SUBJECT: S.P. 6212-167 (T.H. 36 Over Keller Lake) St Paul, MN
Bridge No. 62037 Plan revisions for Abutments and Piers

I've enclosed the revised Plan Sheet Nos. 2R, 10R, 11R, 12R, 13R, 21R, 22R, 23R, 24R, 29R, 30R, 31R, 31AR, 32R, 33R, and 33AR. The details were updated in order to ensure proper fabrication. Please remove and discard Sheet Nos. 2, 10, 11, 12, 13, 21, 22, 23, 24, 29, 30, 31, 32 and 33 in your original plan set and insert the enclosed new sheets. Thank you.

SUBJECT: S.P. 6212-167 (T.H. 36 Over Keller Lake) St Paul, MN
Bridge No. 62037 Plan revisions for Inverted Tee Beams and Deck
Reinforcement

DES: MDH DR: TKB APPROVED: 8/5/13
 CHK: NJV CHK: DCH
 SHEET NO. 21R OF 68 SHEETS BRIDGE NO. 62037

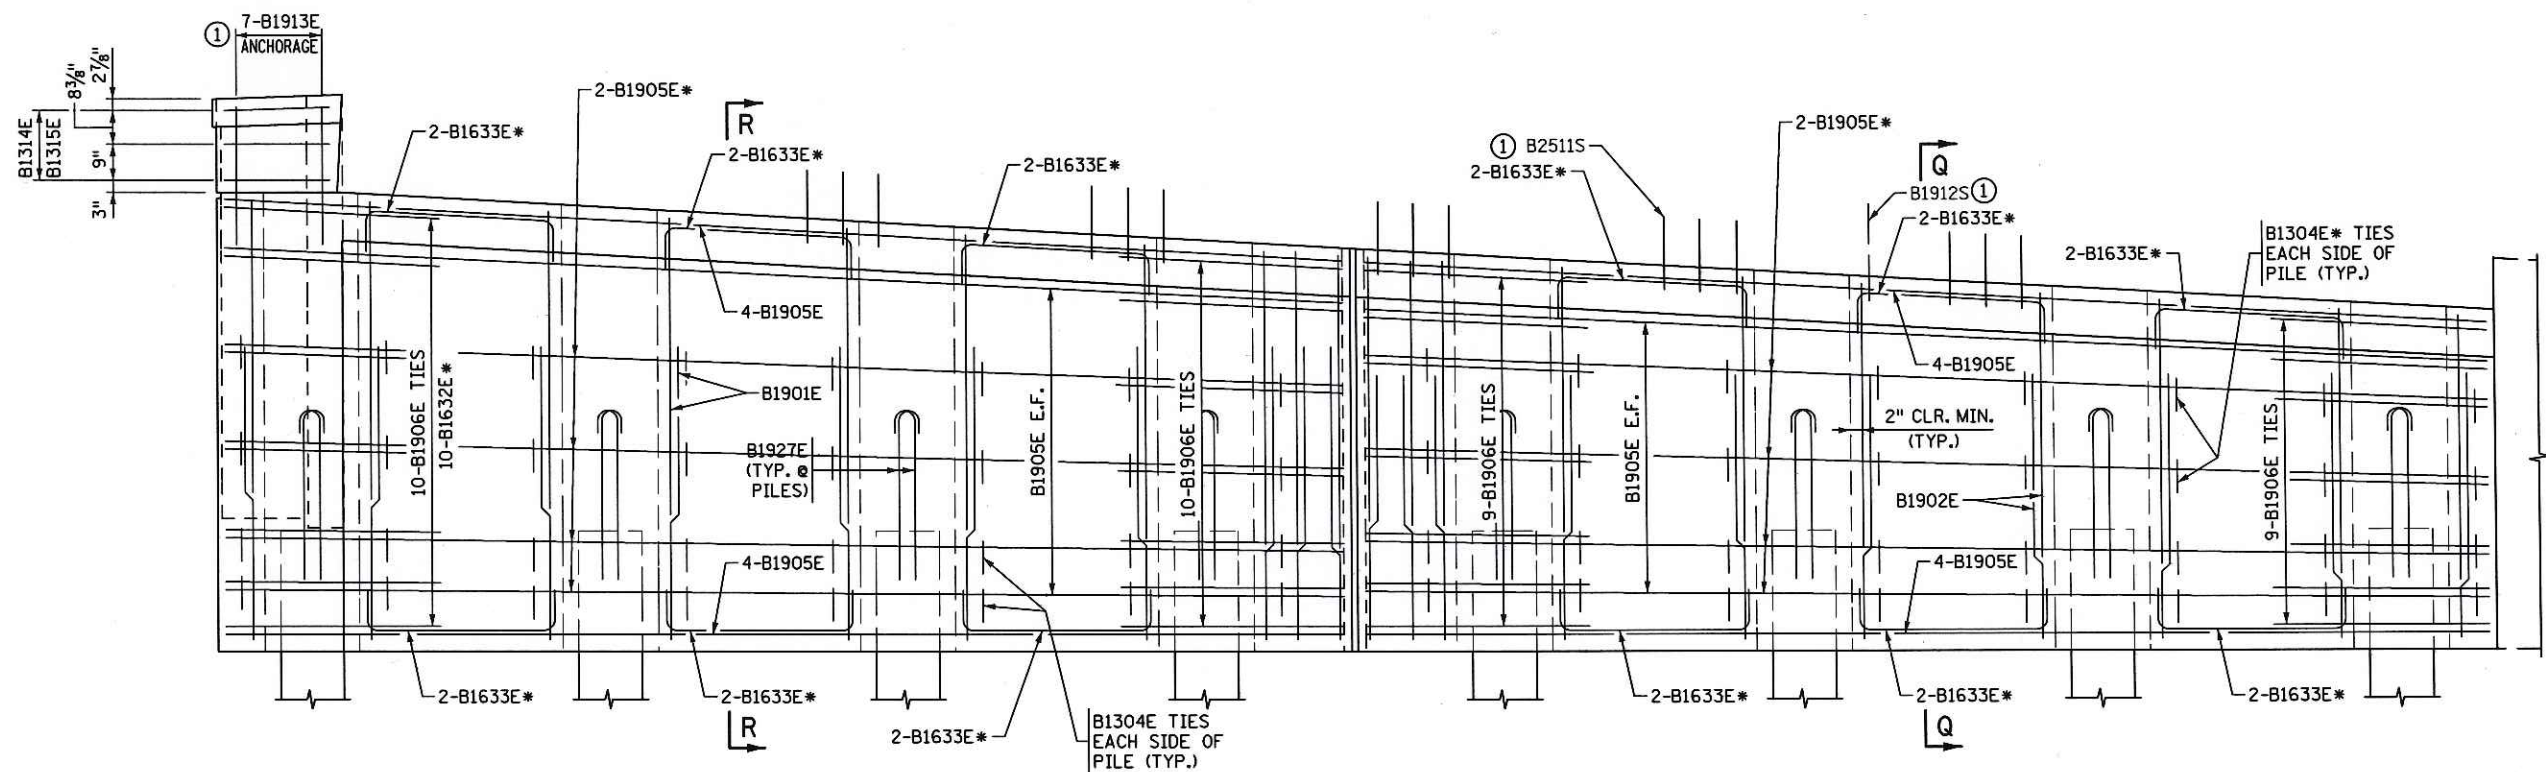
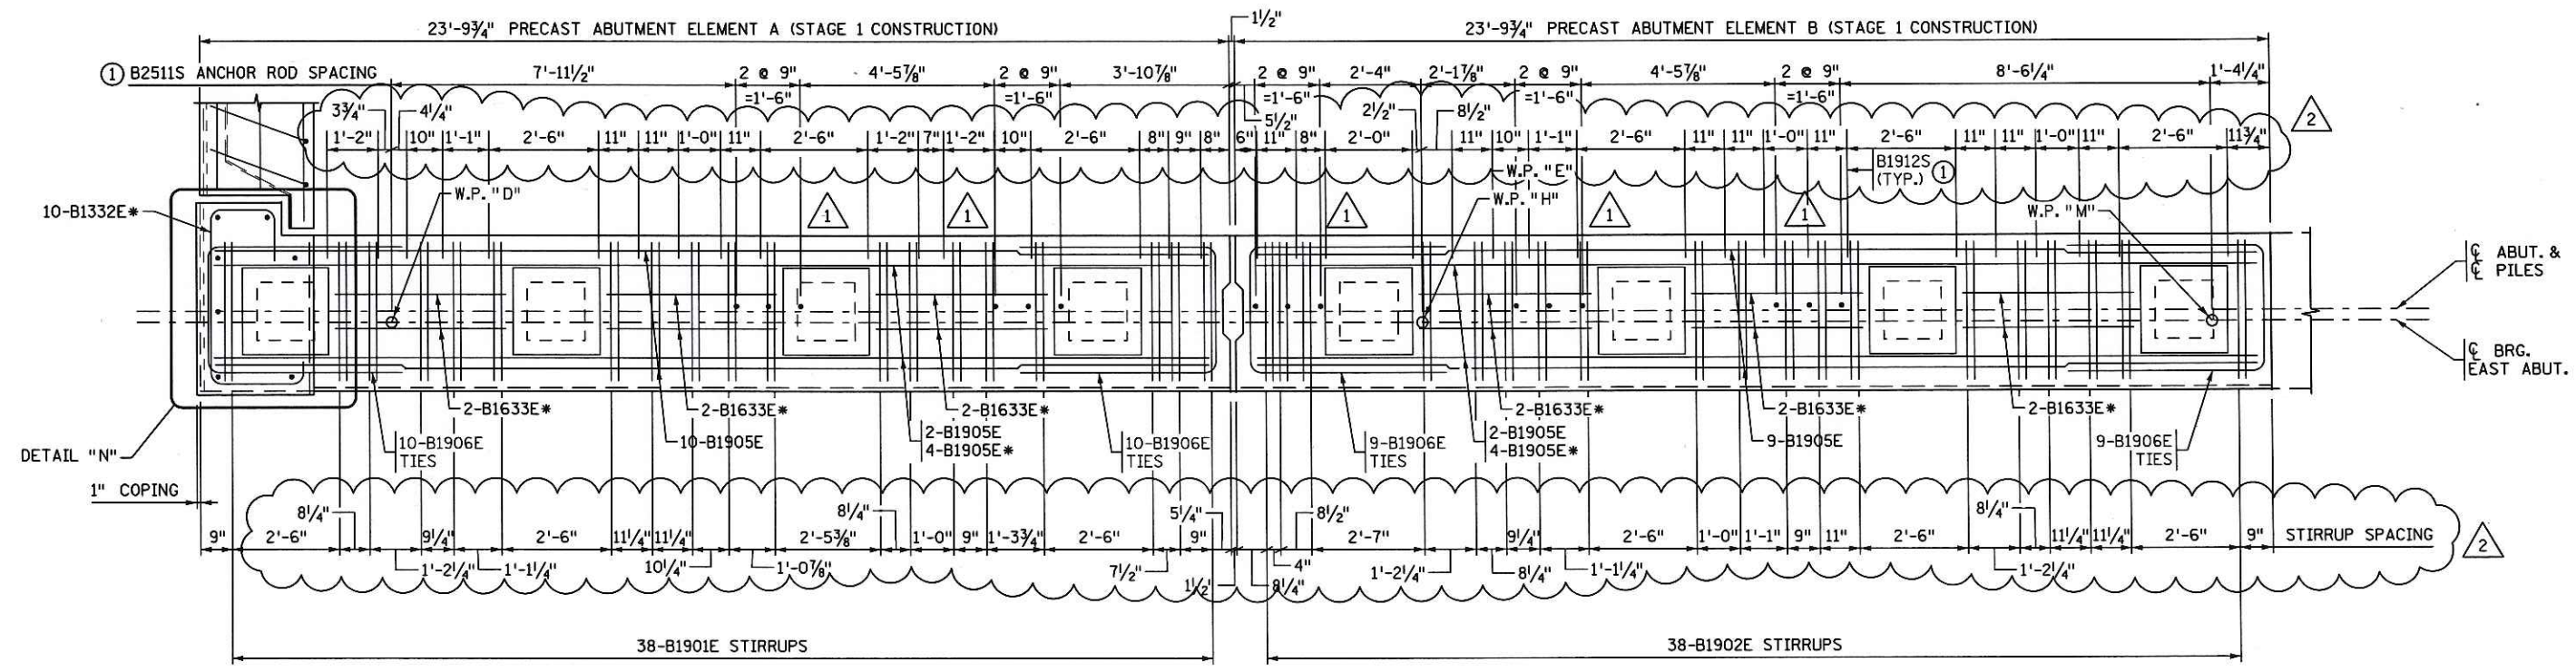
*- DENOTES ADDED REINFORCEMENT.

REVISION		
DATE	DESCRIPTION	APPROVED BY
5/3/13	REPOSITIONED B2511S ANCHOR RODS	AMS
5/21/13	ADDED REINFORCING FOR EASE OF FABRICATION	AMS

DES: MDH DR: TKB APPROVED: 8/5/13
 CHK: NJV CHK: DCH
 SHEET NO. 22R OF 68 SHEETS BRIDGE NO. 62037

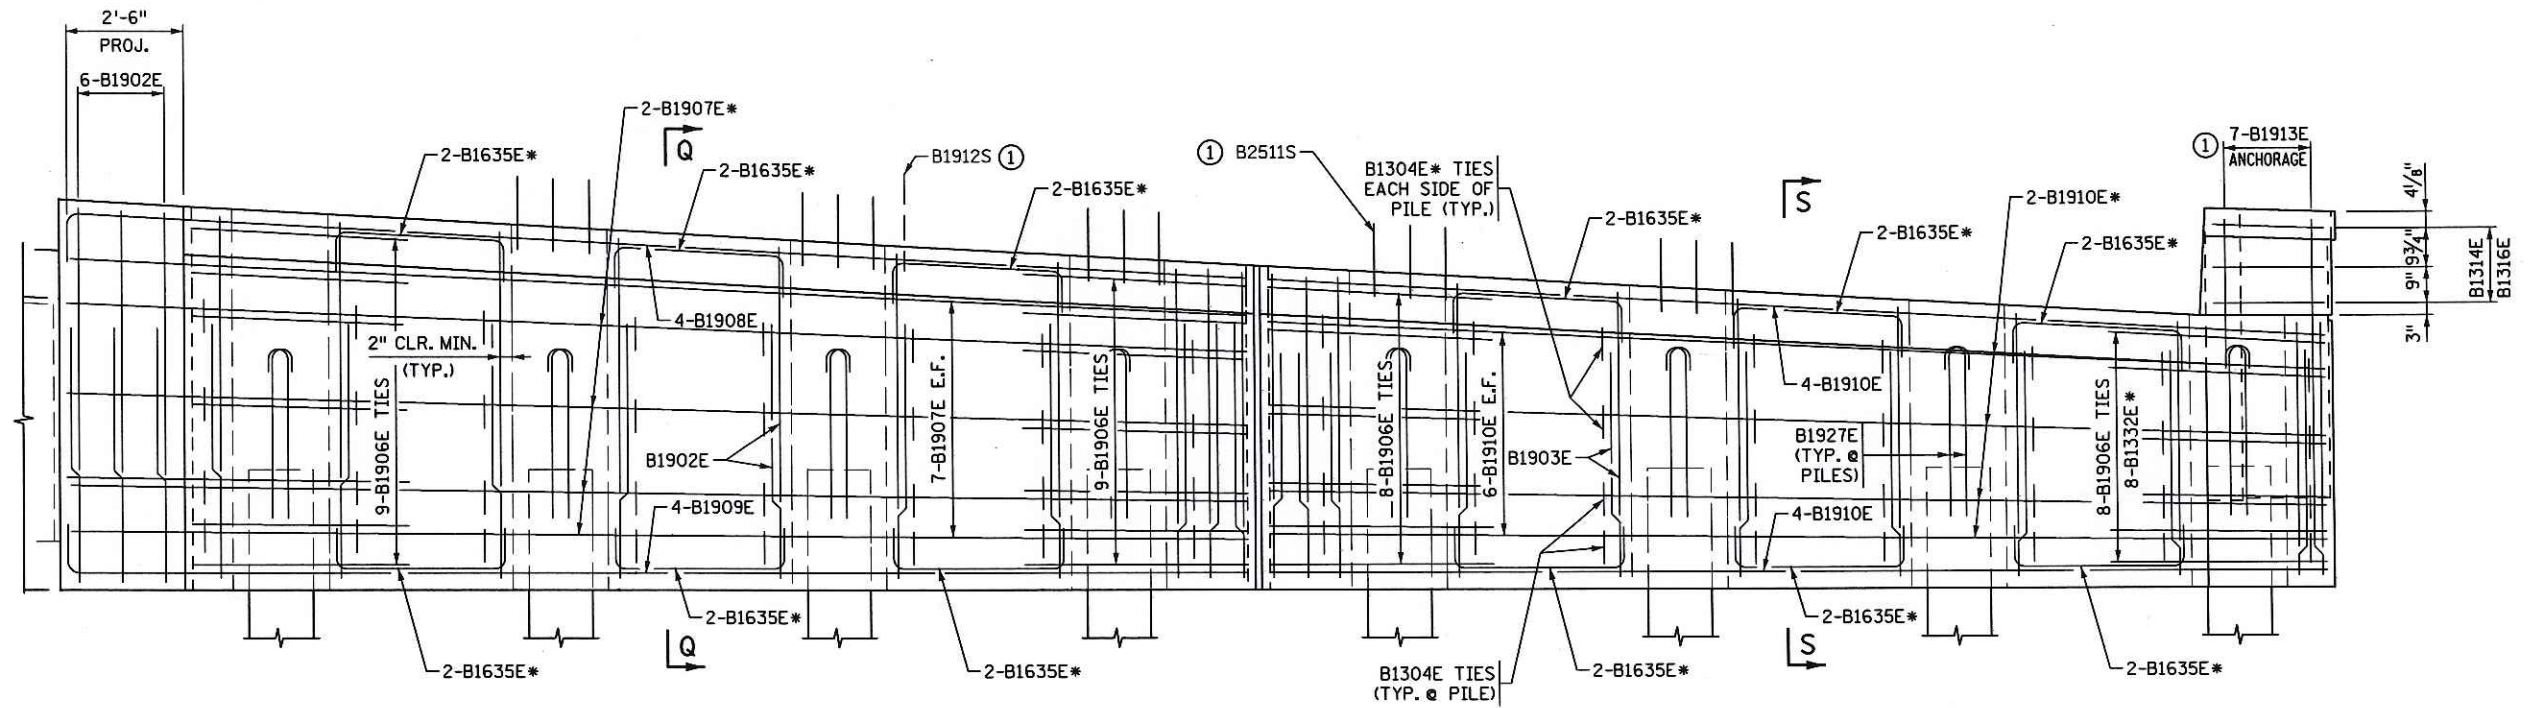
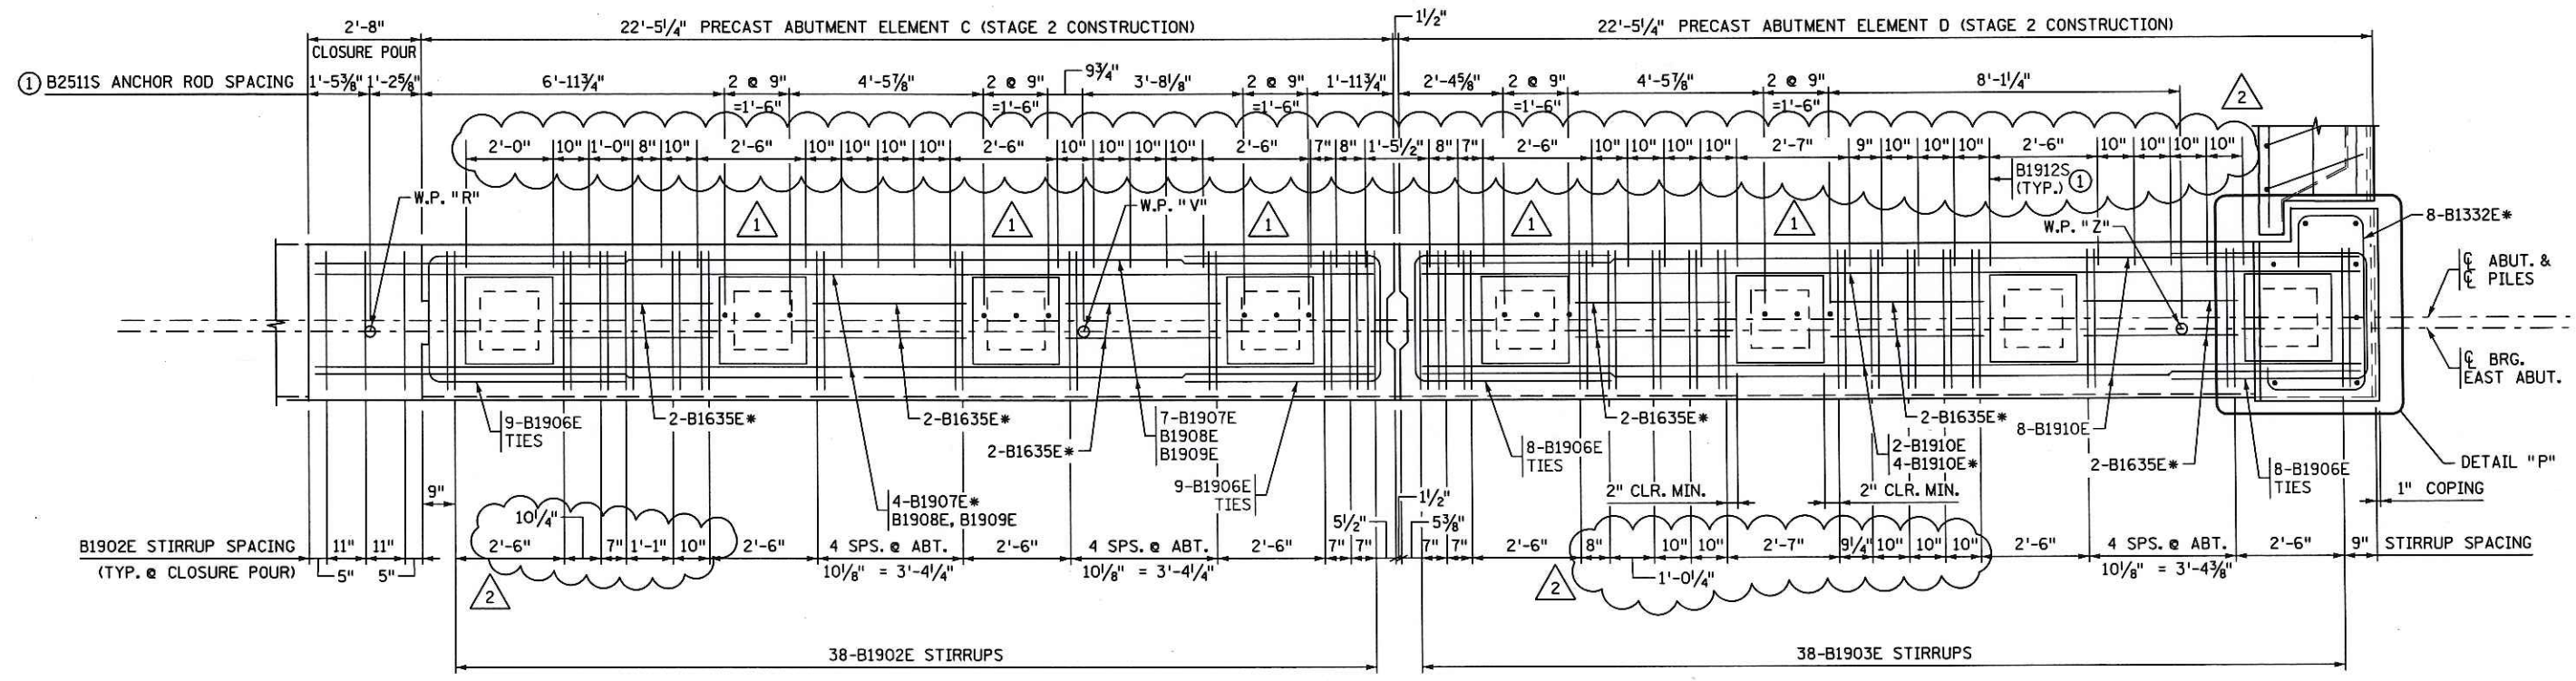
*-DENOTES ADDED REINFORCEMENT.

REVISION		
DATE	DESCRIPTION	APPROVED BY
5/3/13	REPOSITIONED B2511S ANCHOR RODS	AMS
5/21/13	ADDED REINFORCING FOR EASE OF FABRICATION	AMS

BRIDGE NO. 62037
 SHEET NO. 29R OF 68 SHEETS

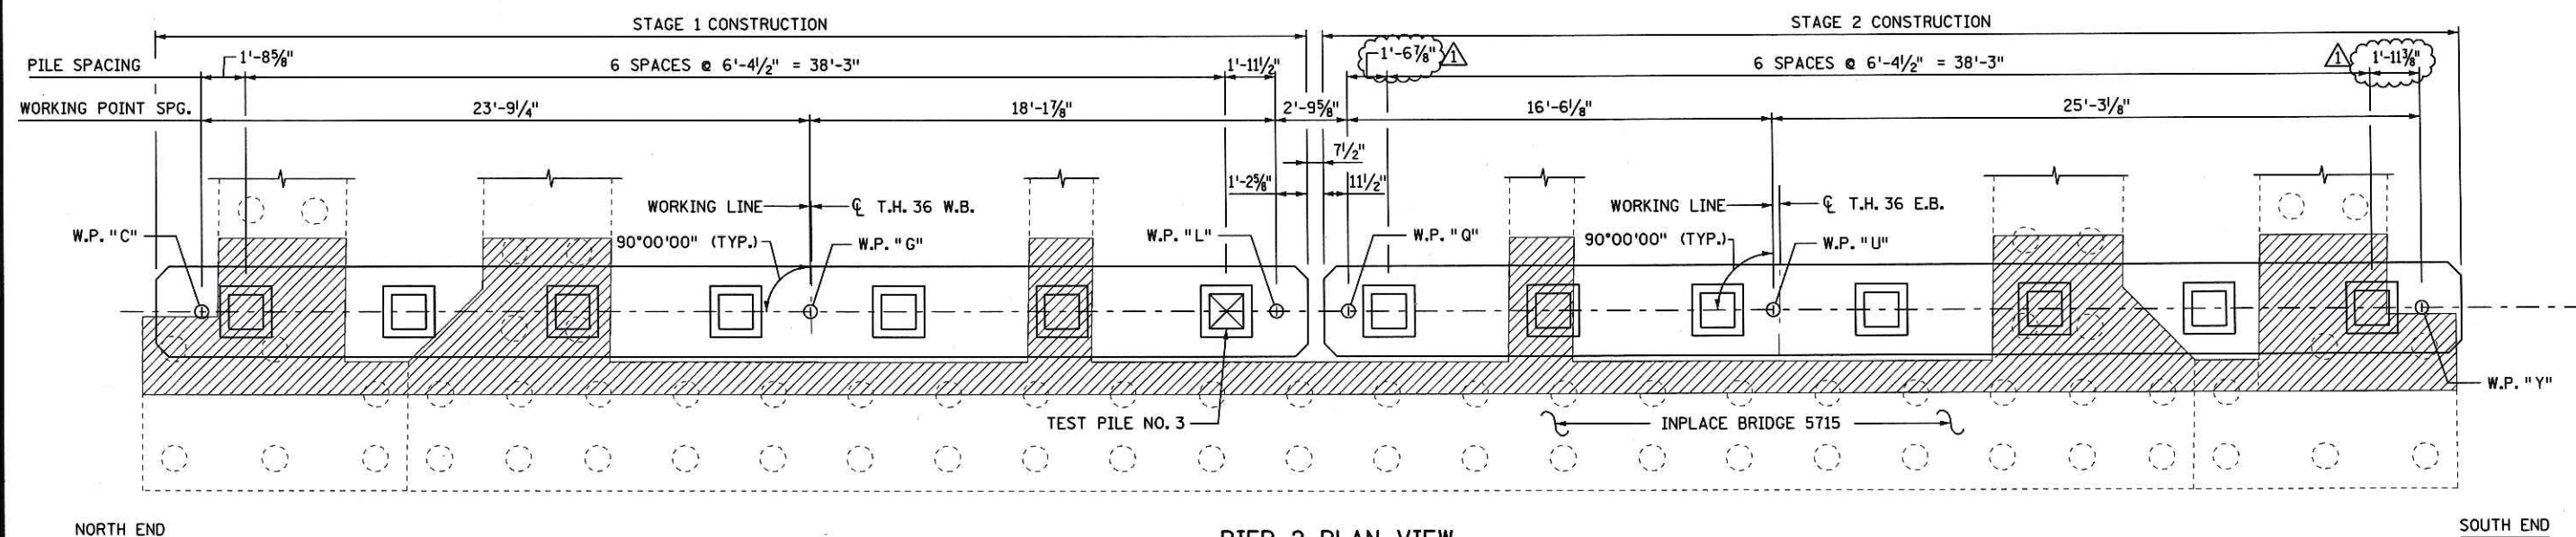
REVISION		
DATE	DESCRIPTION	APPROVED BY
5-21-2013	REVISED DIMENSIONS	AMS

BRIDGE NO. 62037
SHEET NO. 30R OF 68 SHEETS

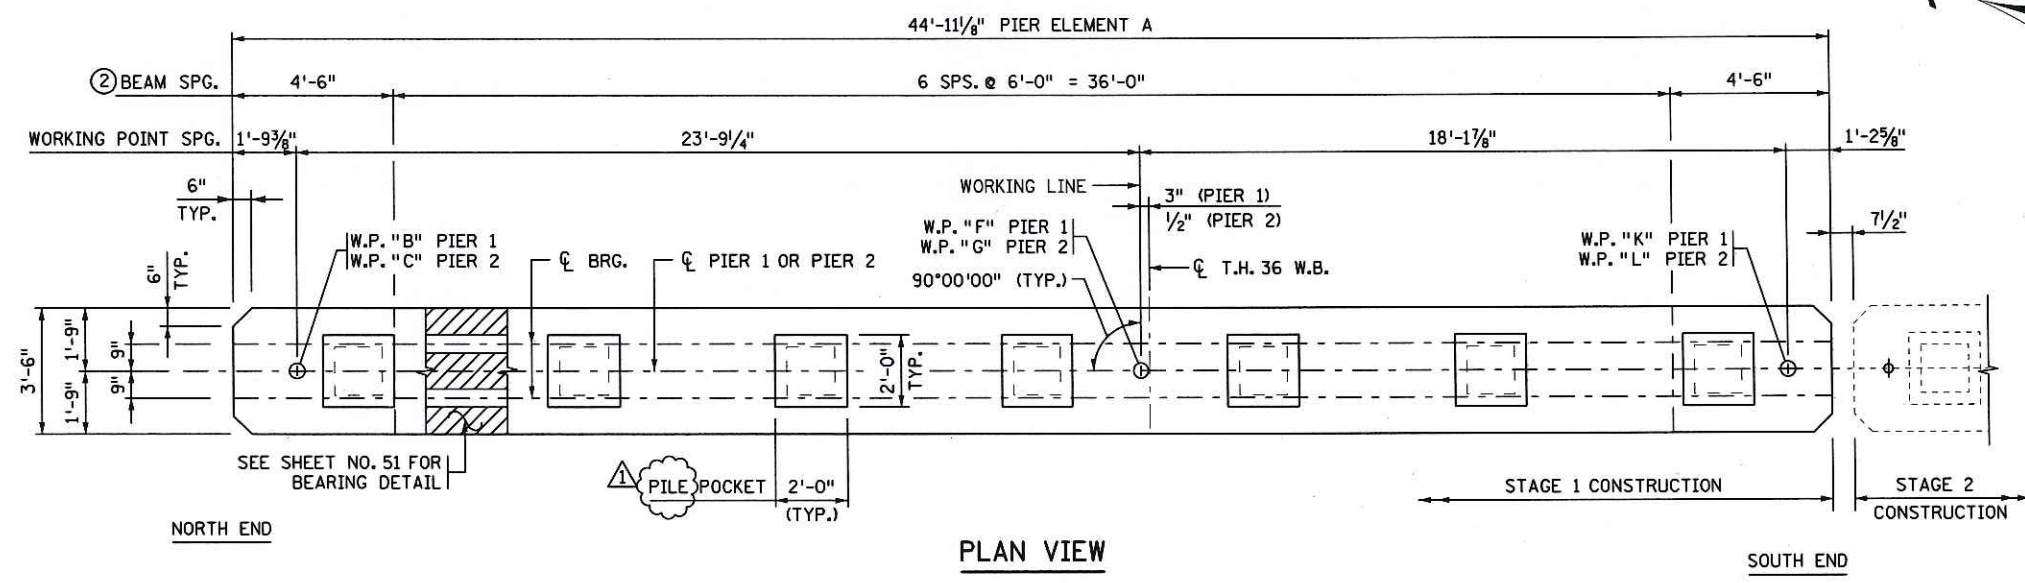
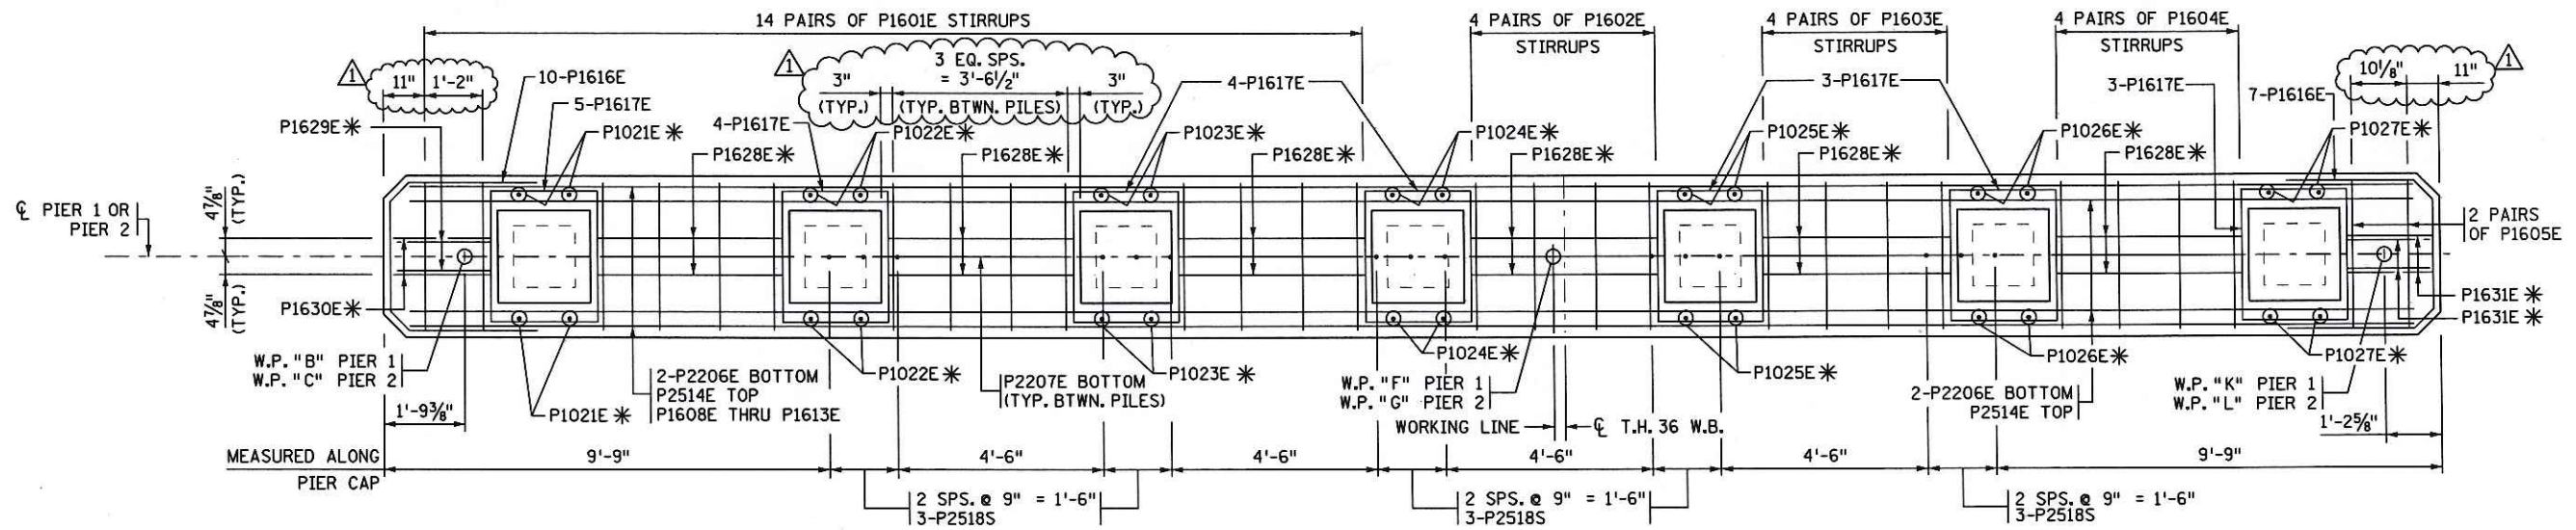
REVISION		
DATE	DESCRIPTION	APPROVED BY
5-21-2013	ADDED REINFORCING FOR EASE OF FABRICATION AND RELOCATED 3/4" V GROOVE	AMS
